State of Wisconsin
Department of Natural Resources

Final Environmental Impact Statement Flambeau Mining Co. — Copper Mine Ladysmith, Wisconsin

March 1990

Figure 1-1
Project Location in Rusk County

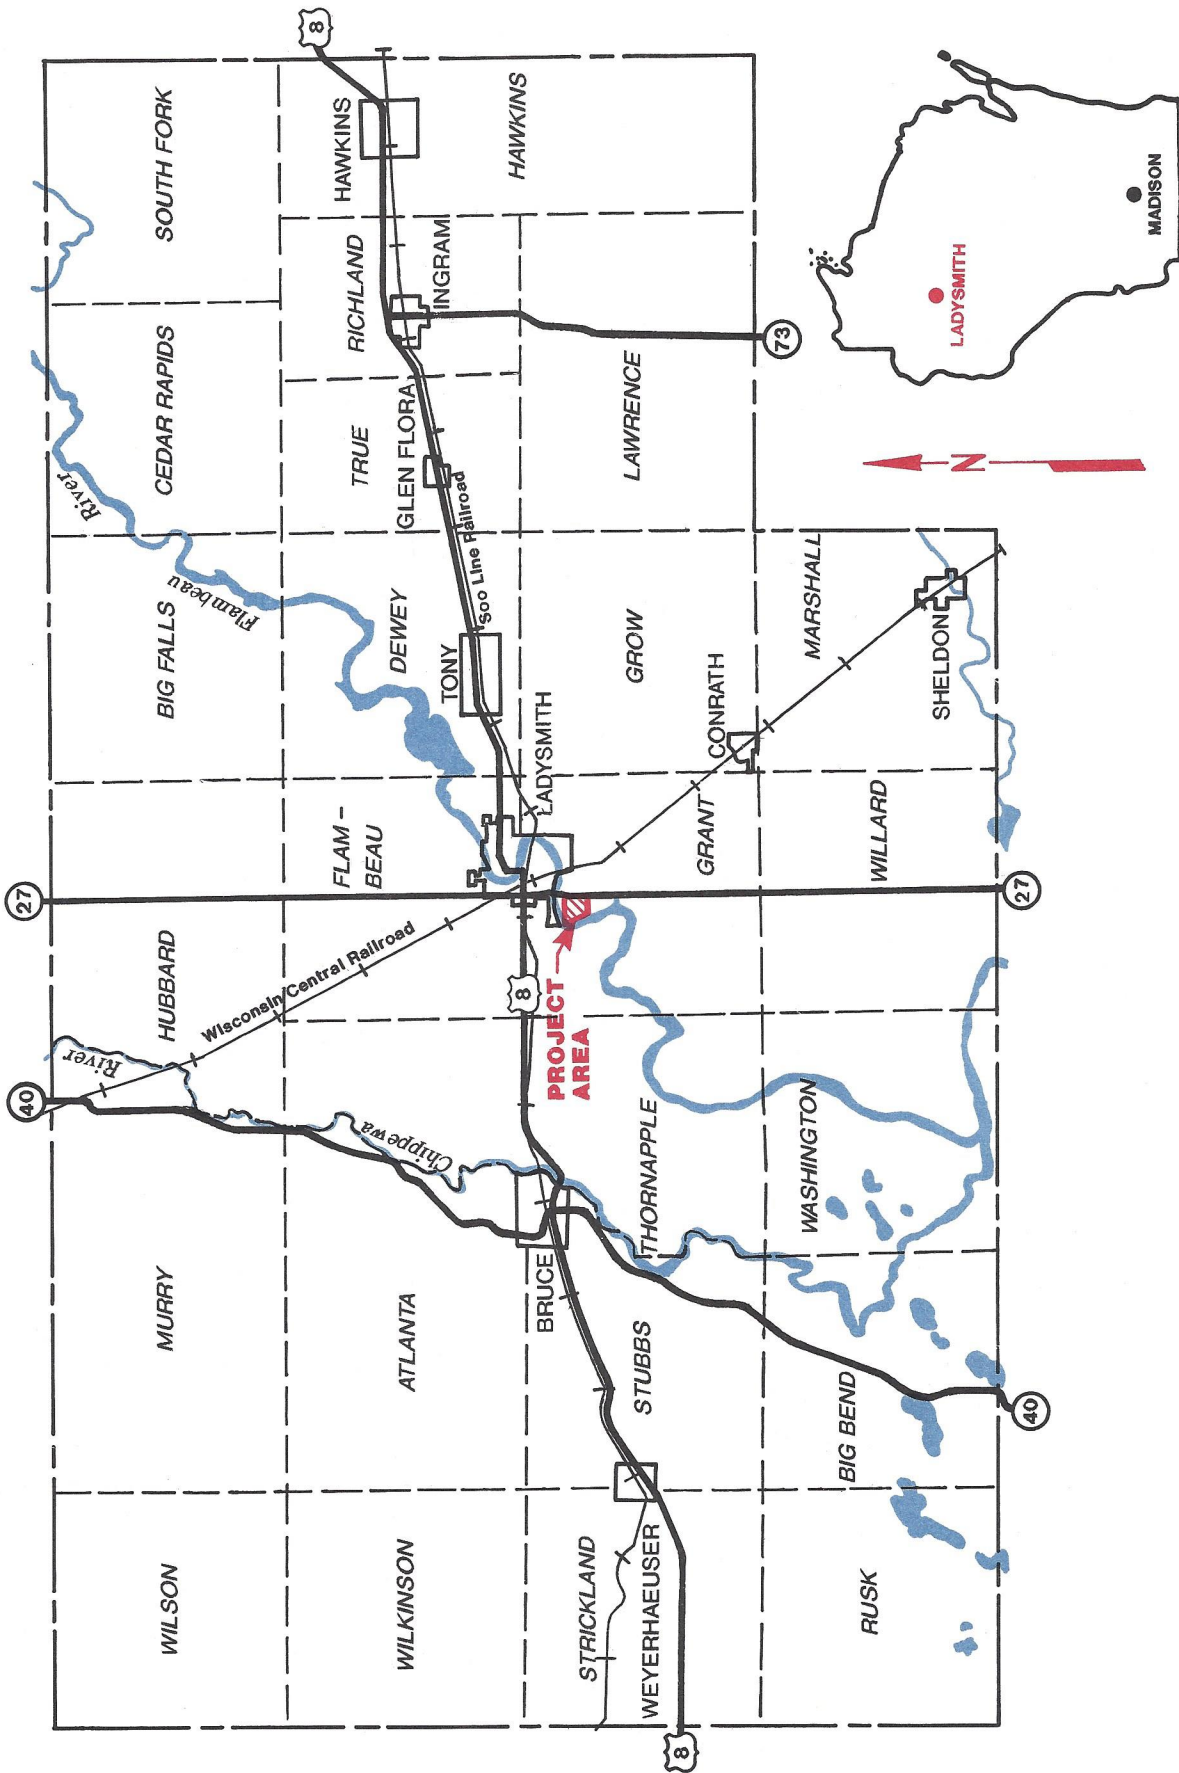
33. Fig 1-1. Add a scale. [TE]
34. Fig 1-2. Clearly delineate "project area," "mine site", and the area subject to the proposed mining permit on this illustration. [TE]

Figure 1-3
Proposed Project
Facilities

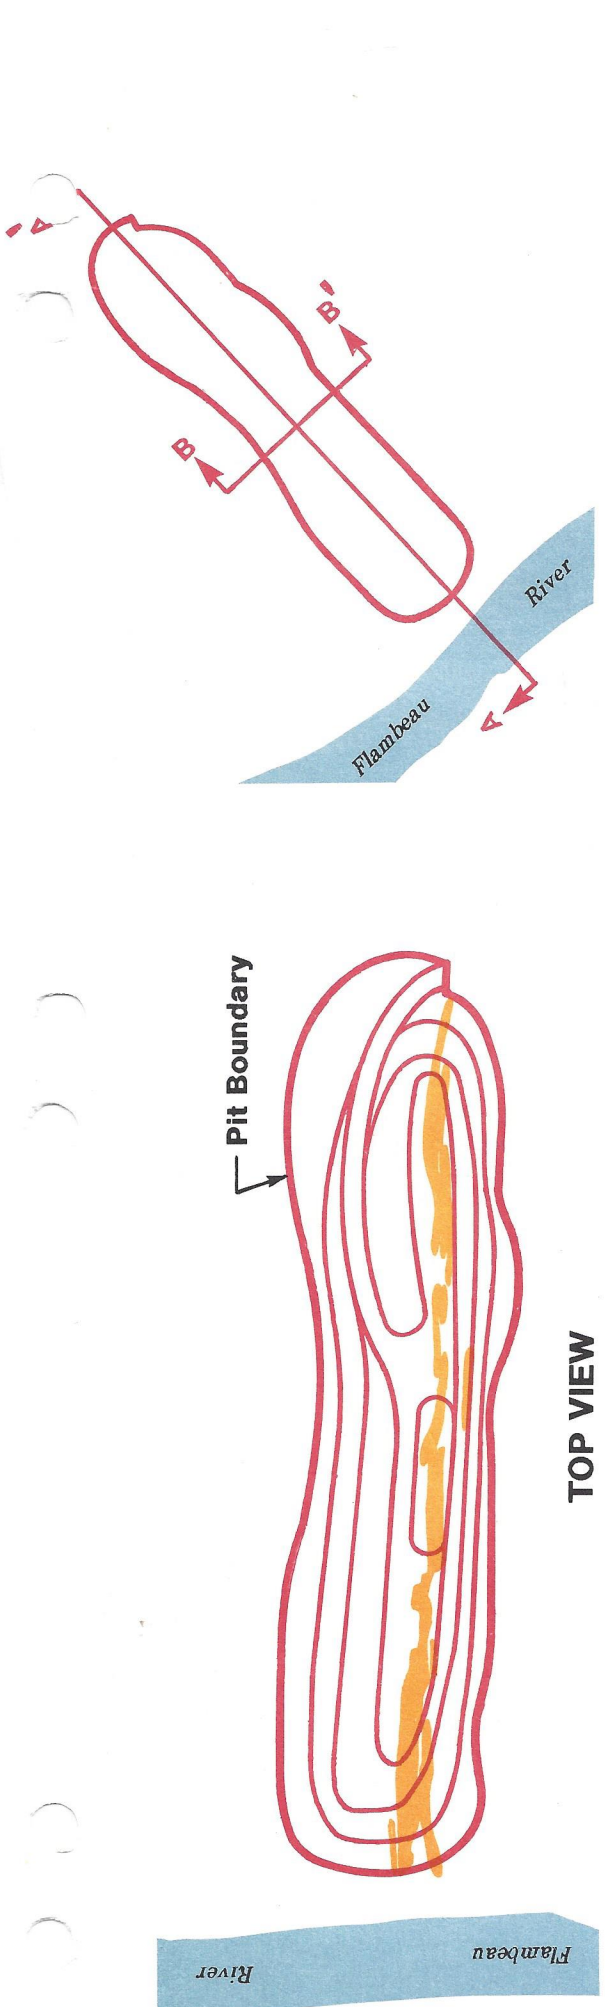
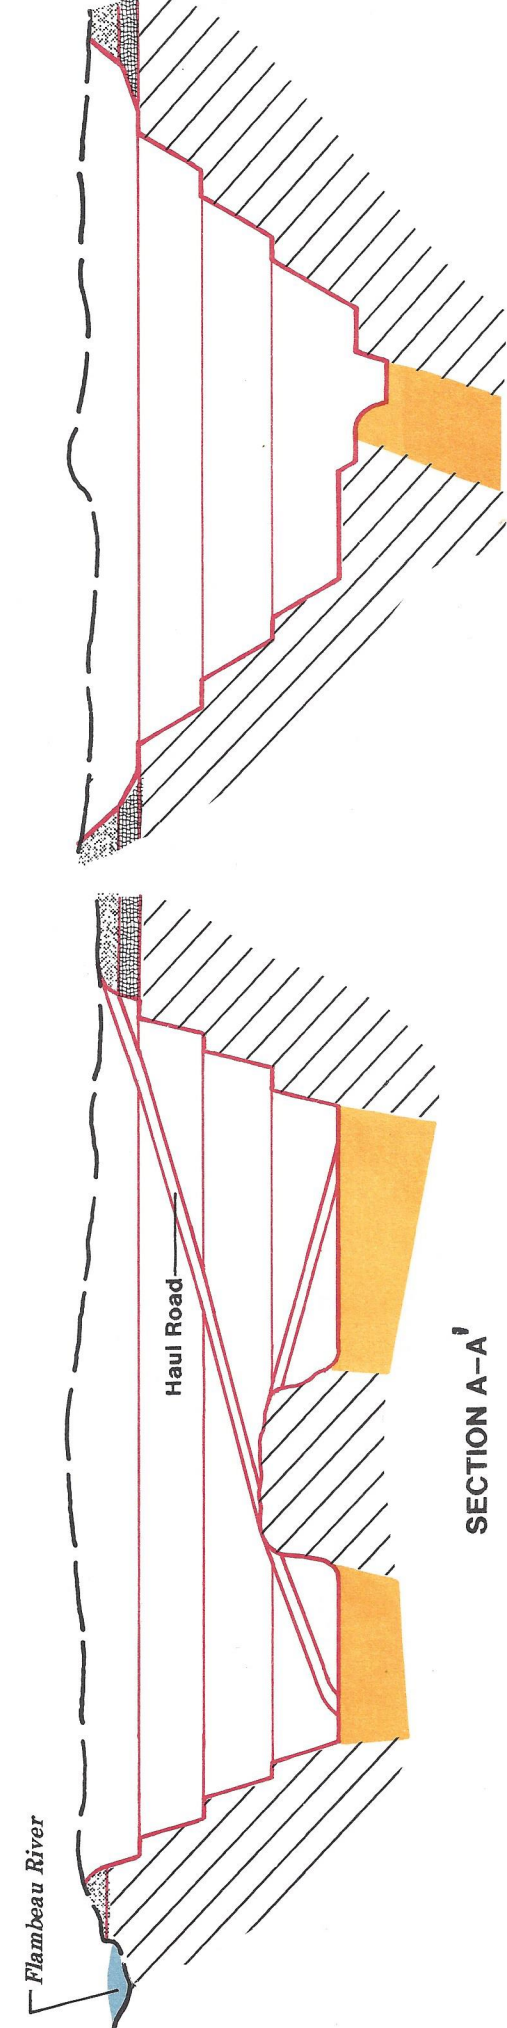
35. Figure 1-3. Figure shows two small buildings (in black) along east edge of fenced area. Will these buildings remain on site or will they be removed? Explanation of the figure should clarify what those structures are in relation to the Proposed Project Facilities. [TE]

Figure 1-4 Open Pit Cross Sections

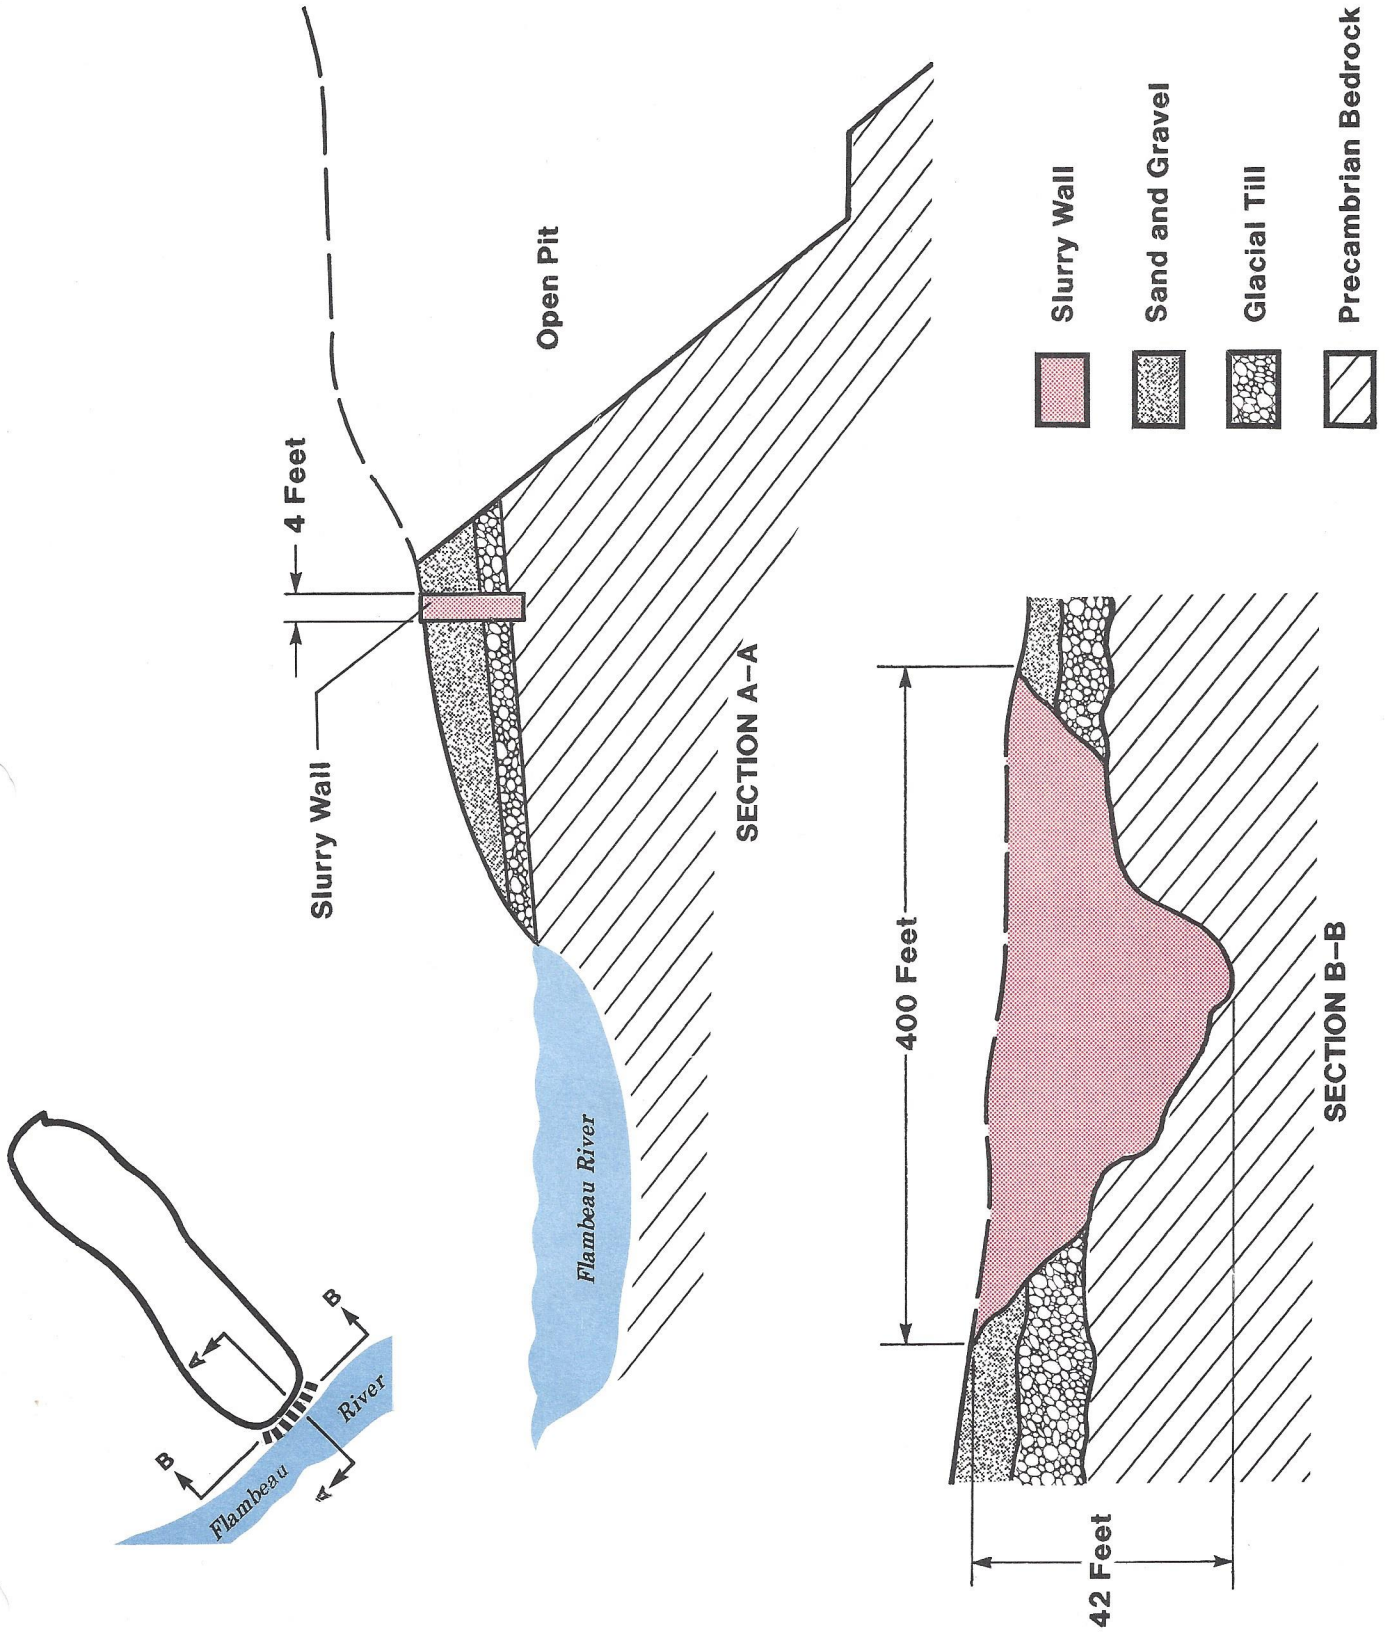
36. Figure 1-4. Use of term "bedrock" appears to exclude the sandstone, but the Cambrian-age sandstone is part of the area's bedrock. The hachure-symbol unit designated "bedrock" should be redesignated as "Precambrian crystalline rock" or "crystalline rock." See Figure 1-5. [MM,TE]

Figure 1-7
Low Sulfur Waste Rock
Stockpile Cross Section
(Not to Scale)

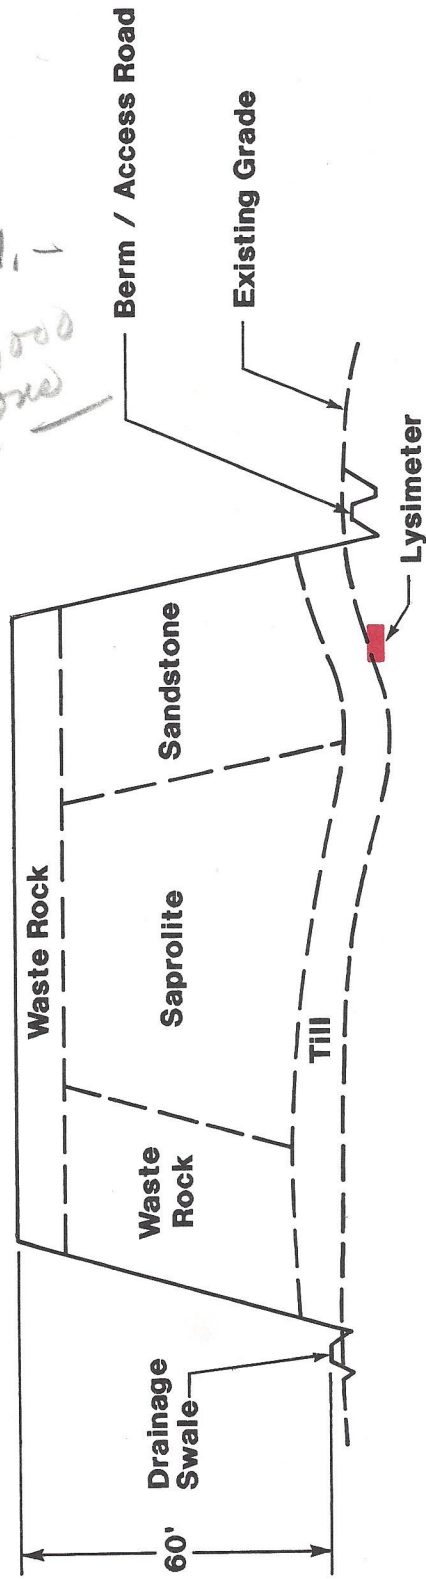
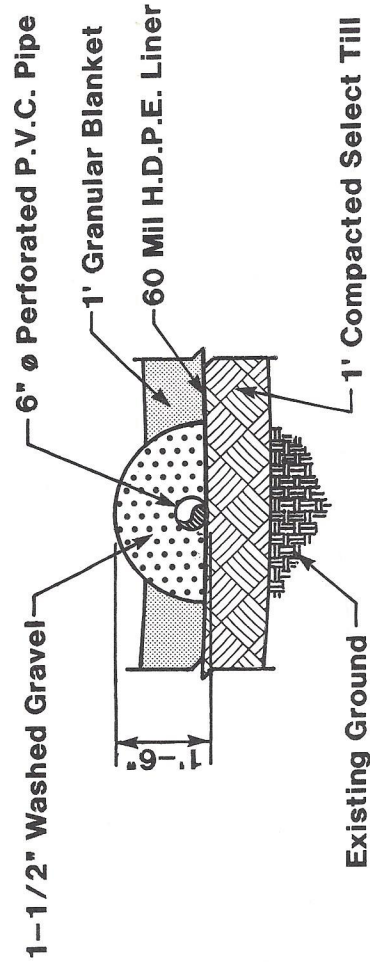
40. Figure 1-7. The Location Map should include a scale. Section A-A, however, should state that no scale is implied; that is, that is a schematic cross-section. [TE]

Figure 1-8
 High Sulfur Waste Rock
 Stockpile Cross Section
 (Not to Scale)

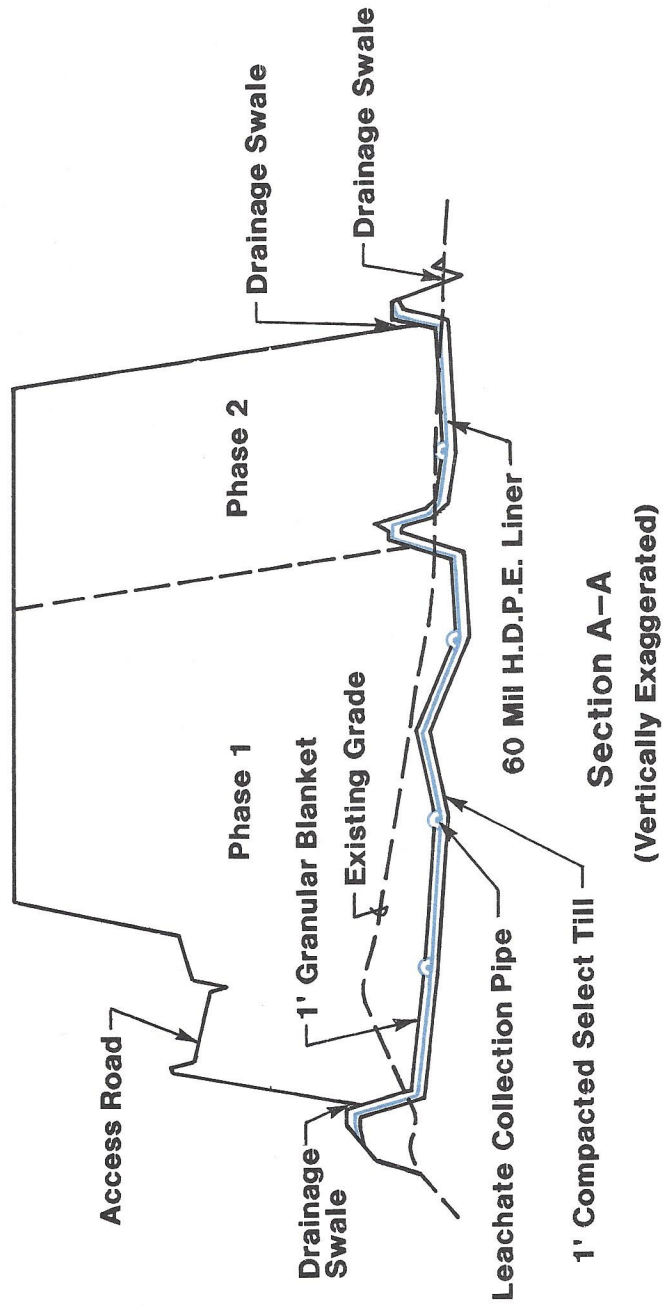
44. Figure 1-8. A scale should be added to both the Plan View and the cross-section view. [TE]
45. Page 12, paragraph 8. The term "lime slaking" should be included in the glossary. [MM]

Figure 2-2
Idealized Cross Section
of the Flambeau Deposit

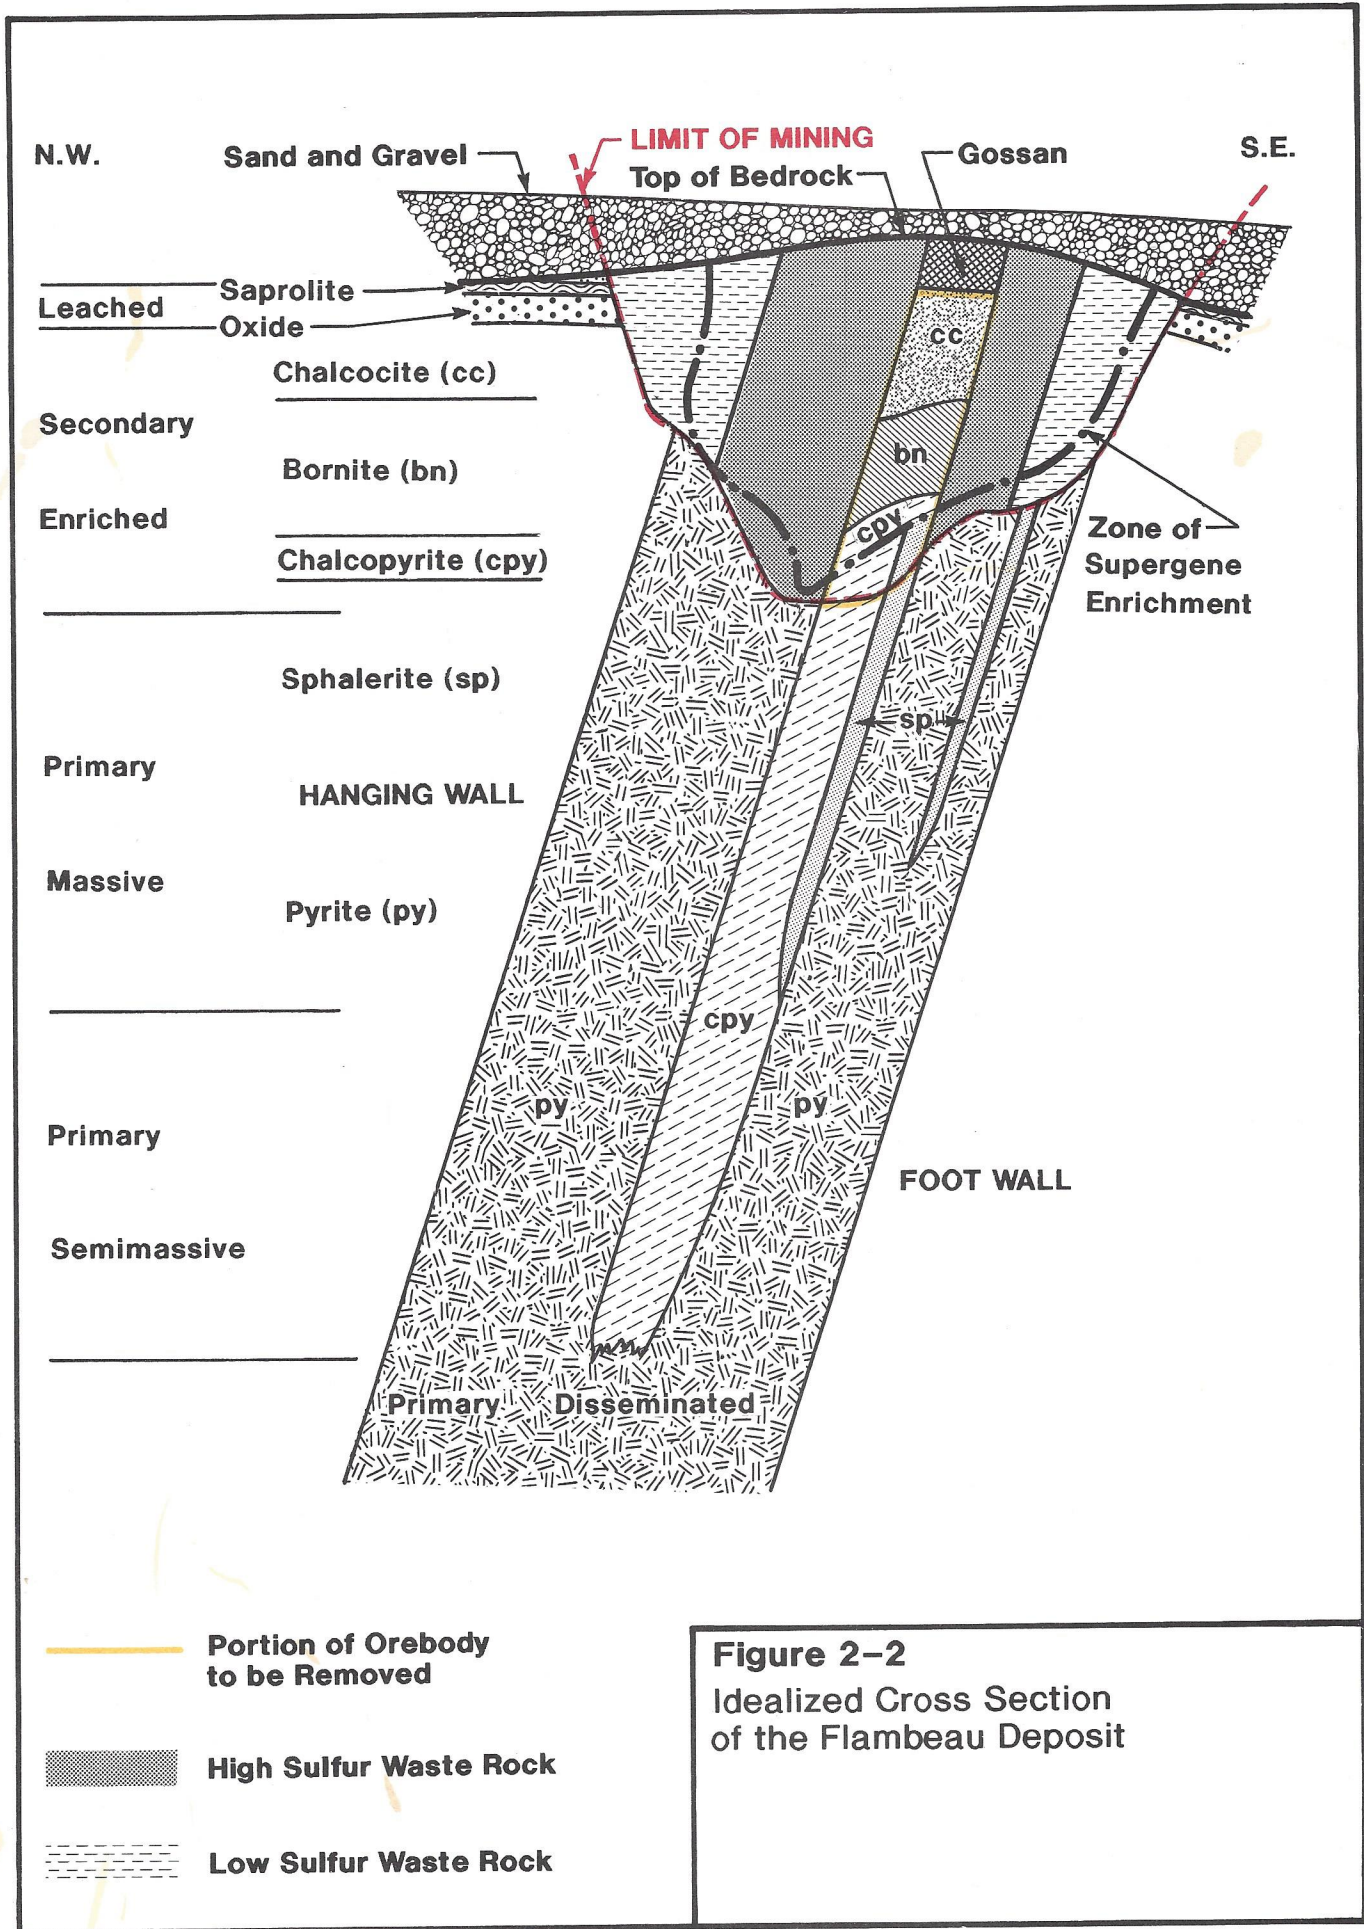
65. Figure 2-2. The composition of the principal minerals should be listed for the reader in an explanation. The box illustrating "Position of Orebody to be Removed" should be redrafted to conform with the illustration; it currently does not. [MW]
